ATTACHMENT I

TECHNICAL SPECIFICATION CHANGES

STEAM GENERATOR SURVEILLANCE

POWER AUTHORITY OF THE STATE OF NEW YORK
INDIAN POINT 3 NUCLEAR POWER PLANT
DOCKET NO. 50-286
November 6, 1981

FIGURE 1

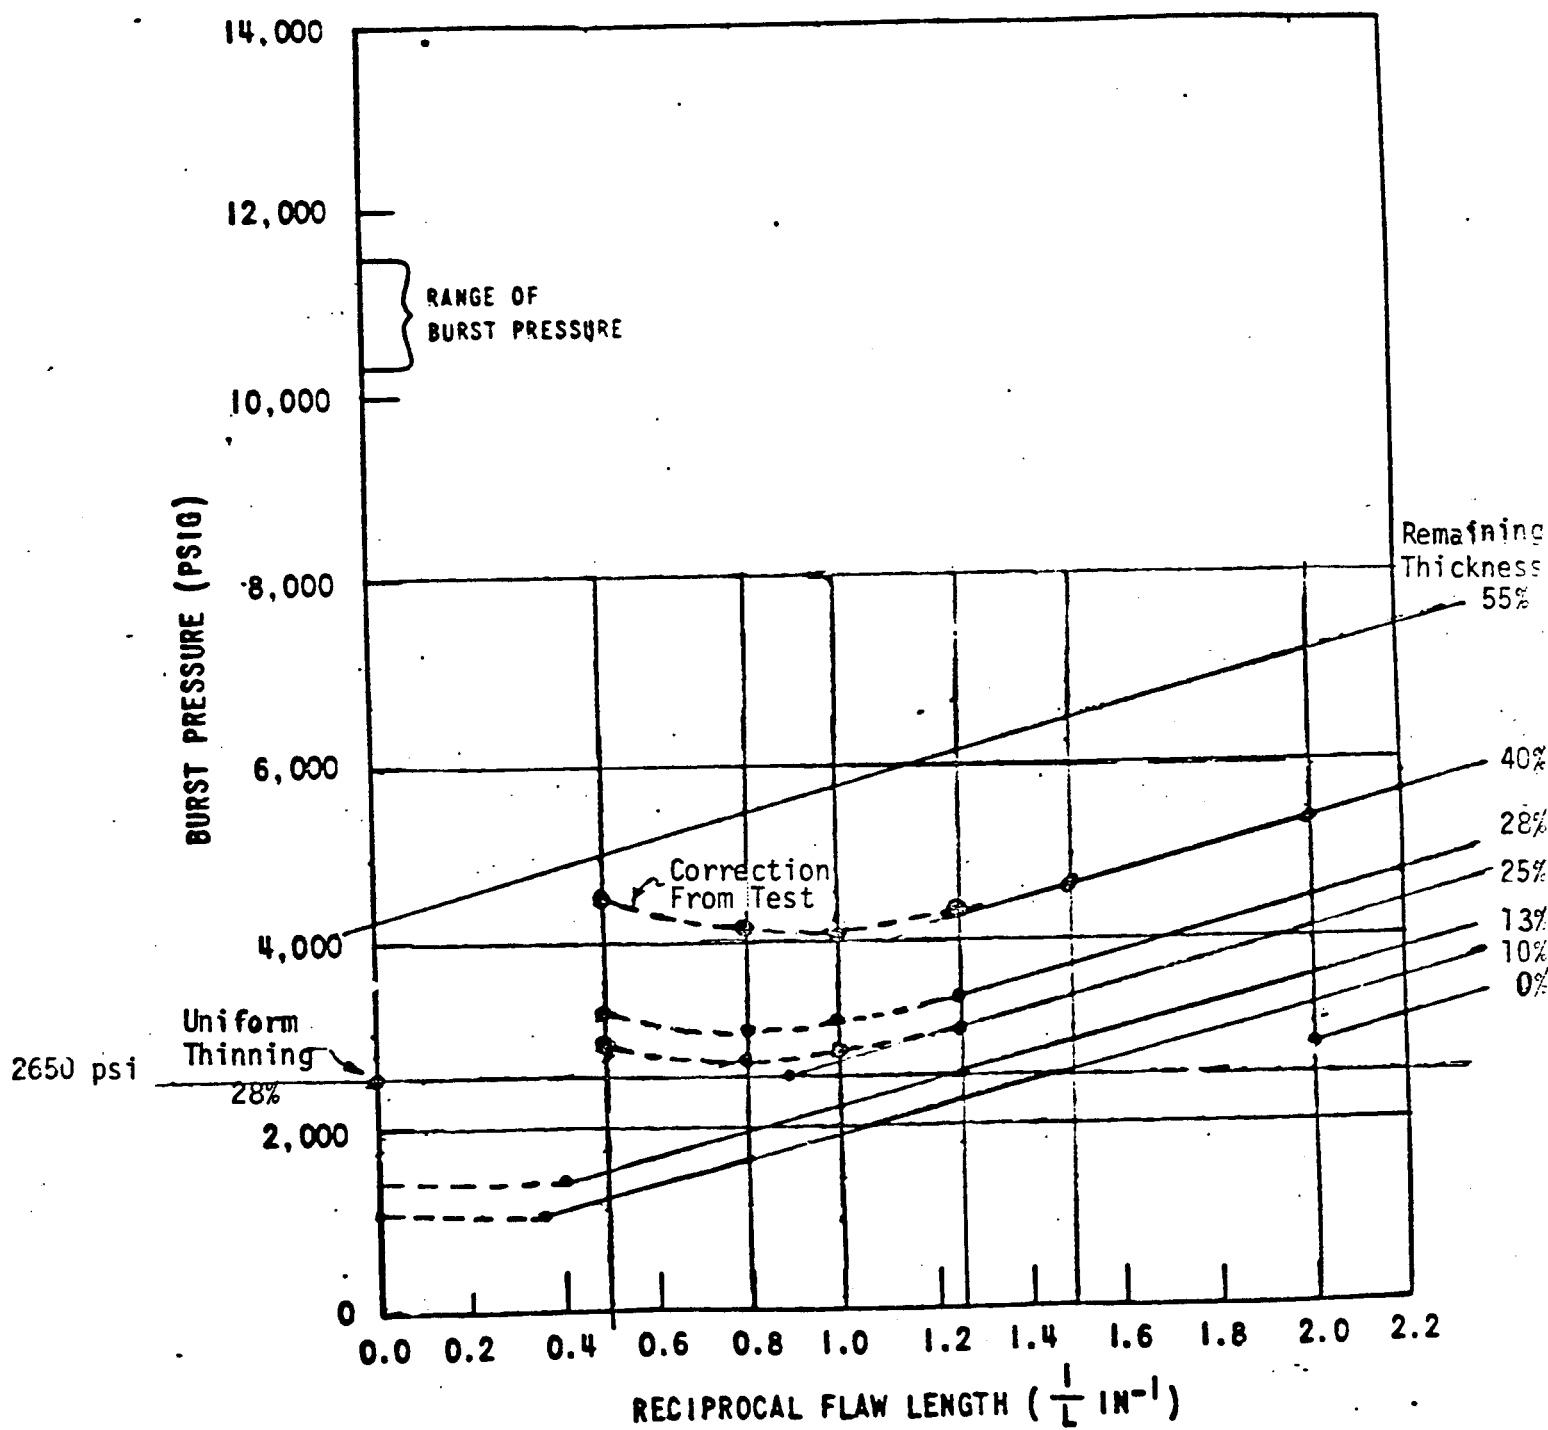
- a) burst tests (corrected to 600° F) of representative tubing with various flaw lengths and remaining wall thicknesses have demonstrated that 25% remaining wall thickness for all flaw lengths is adequate to withstand the maximum ΔP (2650 psi) calculated to occur during faulted conditions (see attached fig. 1). By limiting the increased plugging limit to flaw lengths of 1 inch or smaller, added conservatism is incorporated since a burst strength improvement is not required for multiple segmented flaws, which have a higher burst strength than single defects of the same length.

- b) a pitted tube (R22 C 46) removed from steam generator no. 31 having a measured pit depth of approximately 65% and a pit diameter of approximately .1 inch was pressurized to 10,000 psi with slight bulging but no rupture or leakage. This strength is comparable to a virgin (non-pitted) tube. (see figure 1)
